SONY® Service Bulletin

NO: CTV-98-001

SUBJECT: VERTICAL JITTER; R504 AND/OR R521 DAMAGED

DATE: MARCH 1998

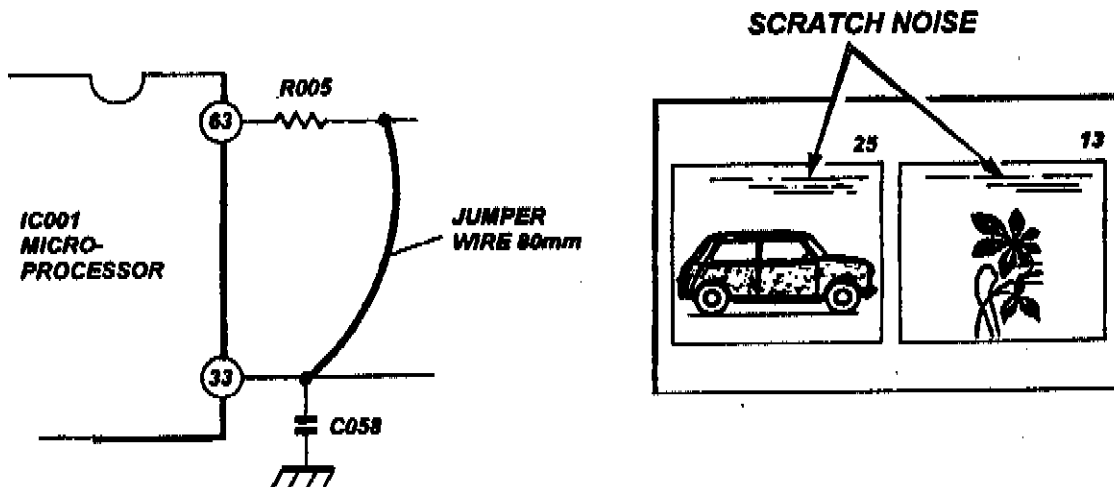
Symptom: If two different signal sources are displayed when in the PIP mode is selected, a scratch noise (lines in picture) may appear in the picture.

1. The PX board must be replaced with **PIN 1-666-471-XX**.
2. Replace the Microprocessor (-001S)CXP85856A-001S (labeled for PIP scratch Noise)
3. Modify the A board (suffix -11): connect the lands of C058 and R005 using a jumper wire (80mm)

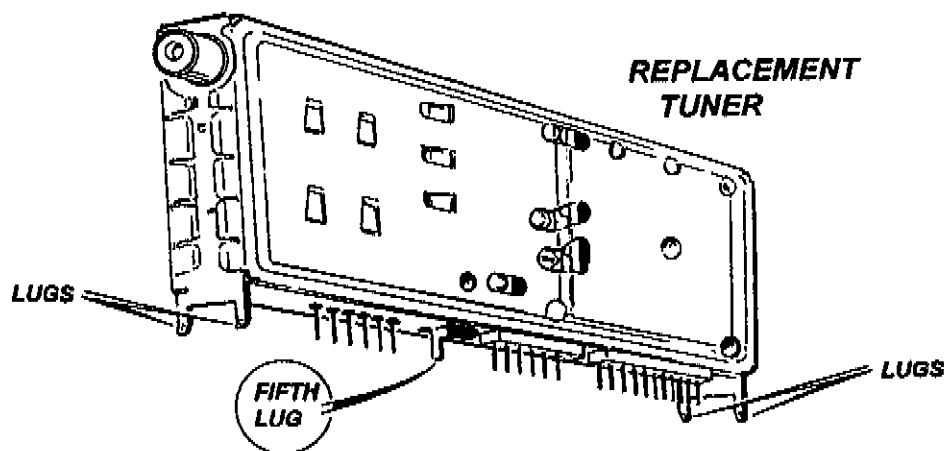
Symptom: New replacement tuner has five ground lugs compared to four on the original tuner. Board does not have a hole to accommodate the fifth lug.

Solution: When replacing the tuner with the new replacement tuner it will become necessary to remove the fifth lug, located in the middle of the tuner.

A BOARD SCHEMATIC GRID LOCATION L-20

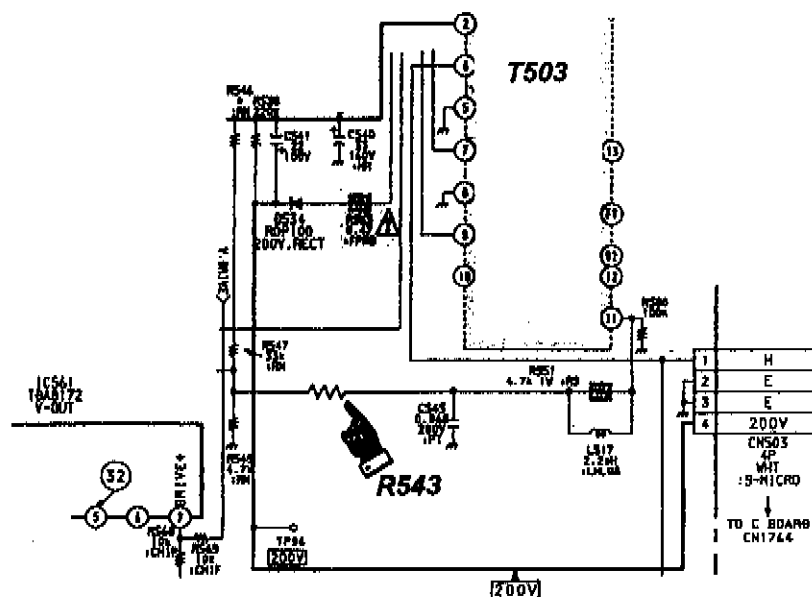
Symptom: The part number for Ref # R543, 0.47 Ohm 1/4W, located on the A board, was not shown in the schematic or listed in the parts list.

REF	DESCRIPTION	PART NUMBER
R543	0.47 OHM 1/4W	1-249-377-11

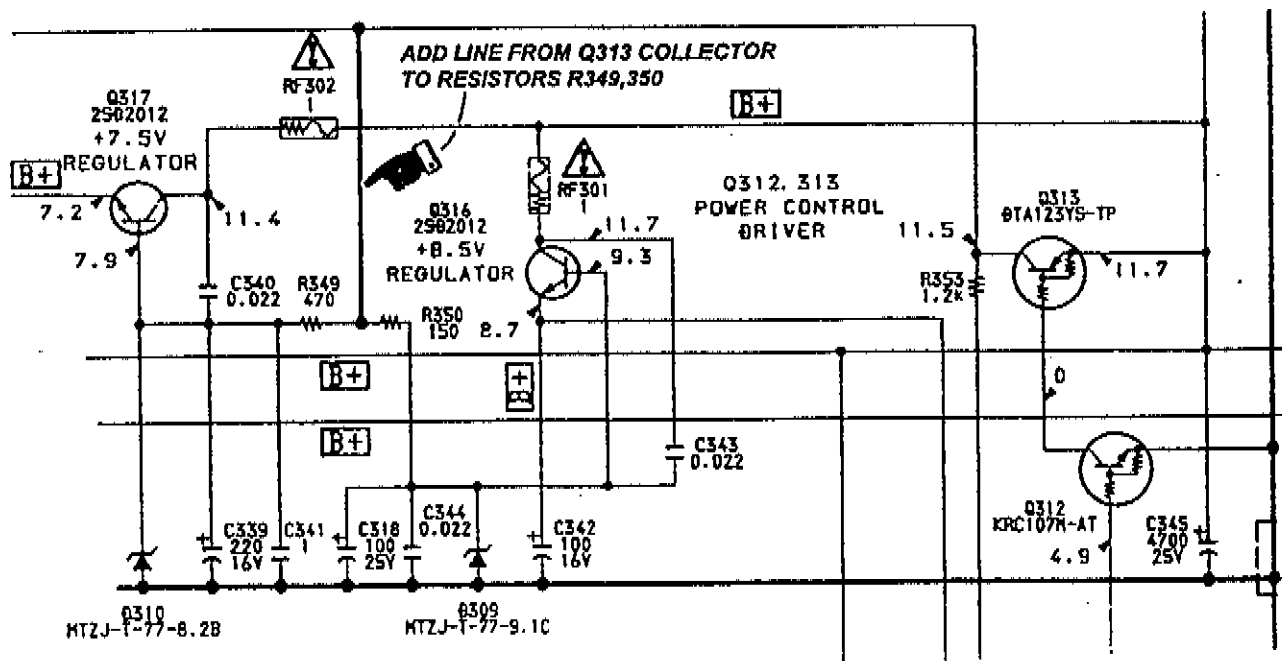
SYMPTOM: The Schematic Diagram of the main board is missing the connection between the Collector of Q313 and the resistors R349 and R350 (see page 39 sections D-15 and E-15). The Trace does show up in the physical diagram.

SOLUTION: Look at the figure below and make the necessary changes to your Manual.

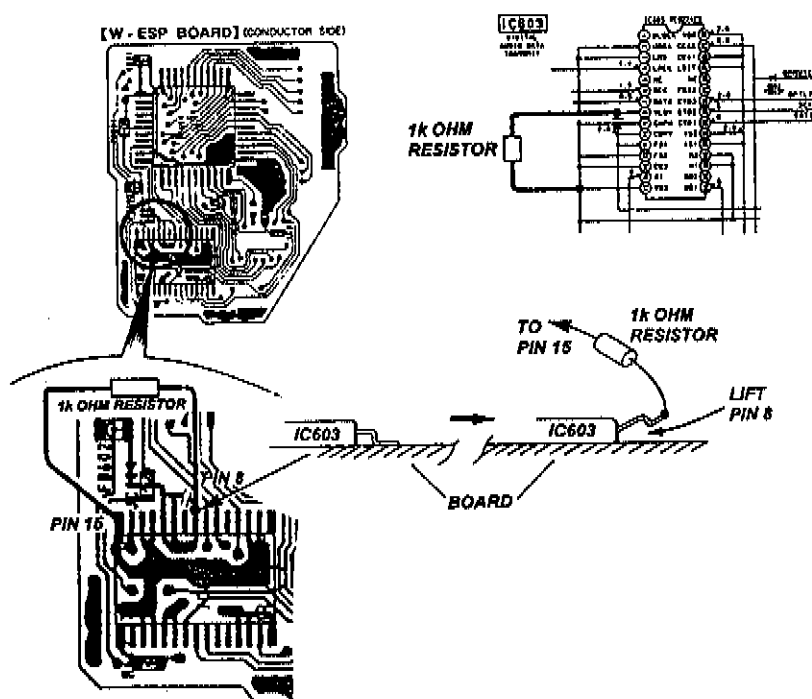
Symptom : When recording from this unit to a Mini disc of DAT player, the level meter on the record device does not respond to the input signal, and / or you are unable to monitor the recording through the record devices output (headphone or line).

Solution: Lift pin 8 of IC 603 of the W-ESP board, and place a 1 k ohm resistor between Pin 8 and Pin 15 of the IC

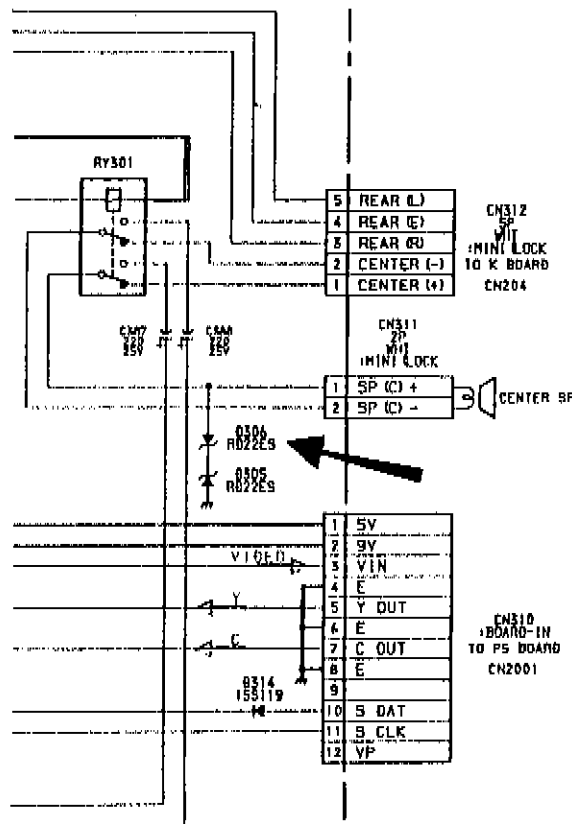
On page 53 of service manual, D304 is misprinted as D306 in the schematic diagram near the centre speaker connector CN311.

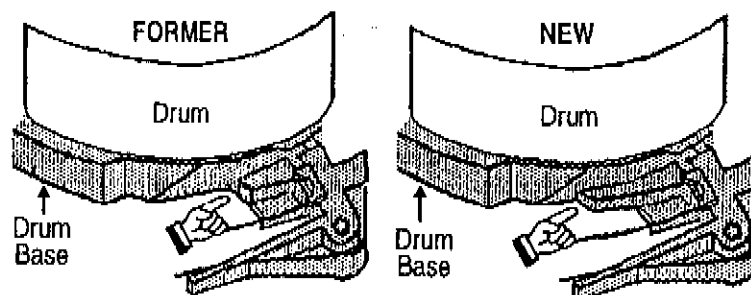
Symptom: Occasionally, for H-Mech models with Drum Base, when the tape is loading/unloading, TG5 may touch the drum causing the heads to be clogged or damaged.

Solution: Replace the "Drum Base" with the new part 3-969-632-04 whenever replacing the "Drum Assy" or the "Upper Drum Assy".

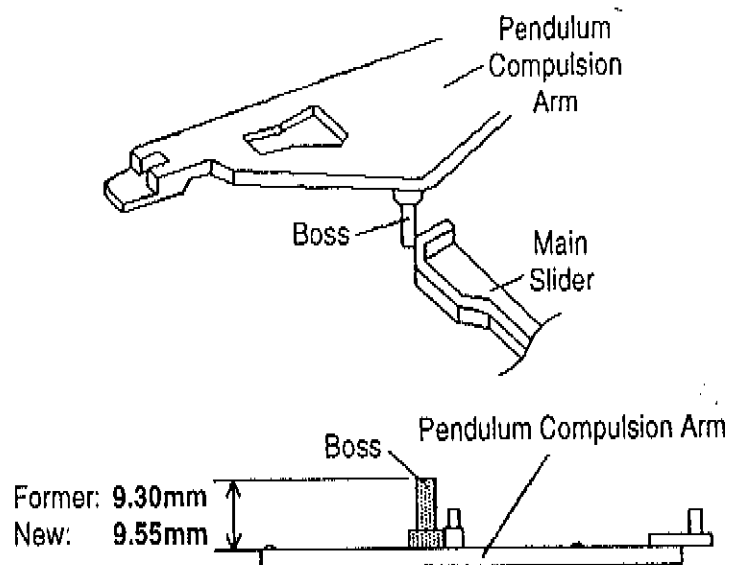
SYMPTOM: Occasionally the set does not start playing back, especially right after loading a cassette. At the same time, a reel rotation error appears on the display.

CAUSE: The "T Reel" does not rotate as the boss of the "Pendulum Compulsion Arm" blocks the "Main Slider".

SOLUTION: Replace the "Pendulum Compulsion Arm" with the new part 3-960-138-03.

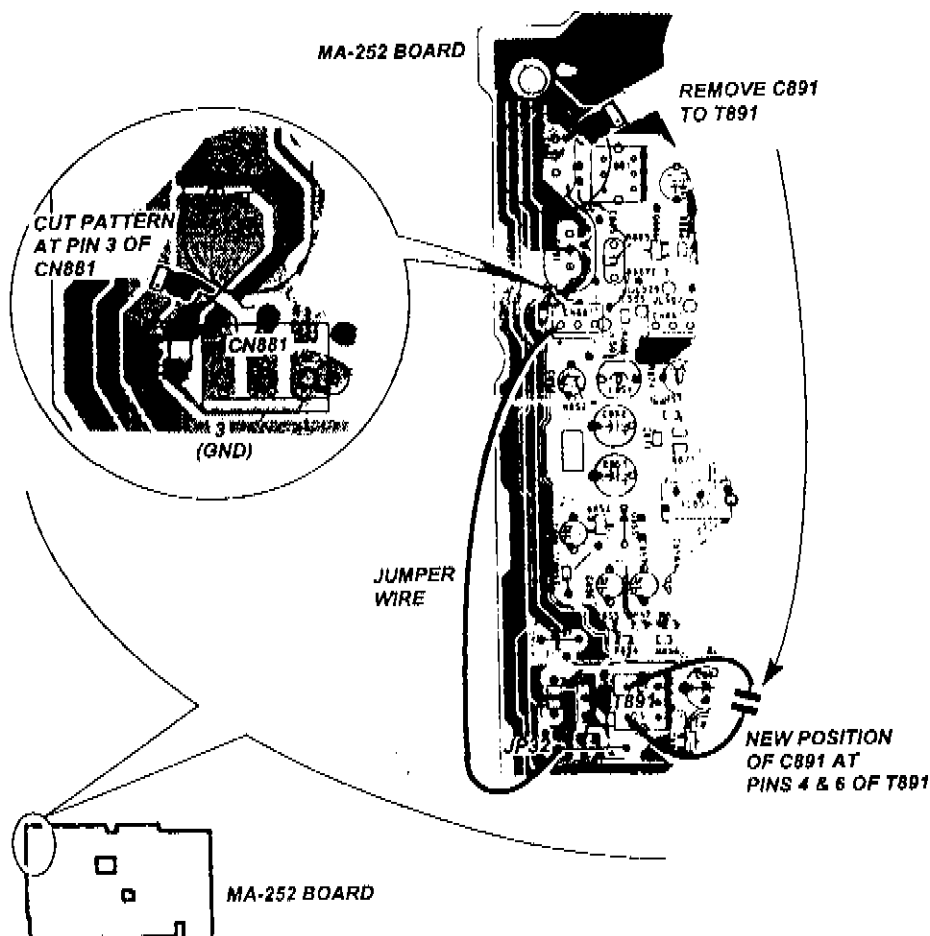
Symptom: When playback of normal audio on OA tape, a beep may be heard. This beep is caused by the difference of oscillator frequencies between the Full Erase and Audio Erase oscillators which might be recorded on tape.

1. Remove C891 and re-mount it between pin 4 and 6 of T891.
2. Cut the pattern on CN881 pin 3 (GND) and connect it to JP 32 land using a wire.

1. SLV-640HF, 740HF, 741HF, 780HF, 940HF

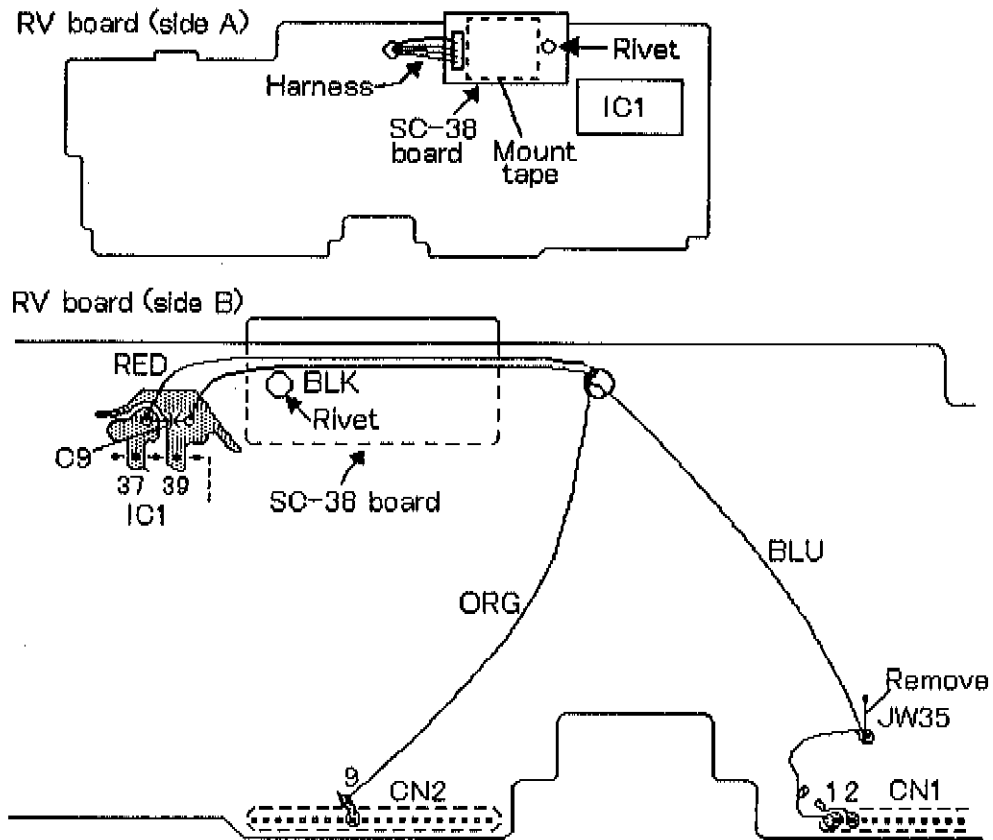
SYMPTOM: Occasionally the following drum servo errors may occur when recording or playing back a tape:

SOLUTION: Install the "SC-38 Service Kit" (A-7092-701-A) as shown below. The kit consists of a mounted SC-38 Board, a Harness, and a Rivet. The wires of CN001 on the SC-38 Board are coded as listed below.
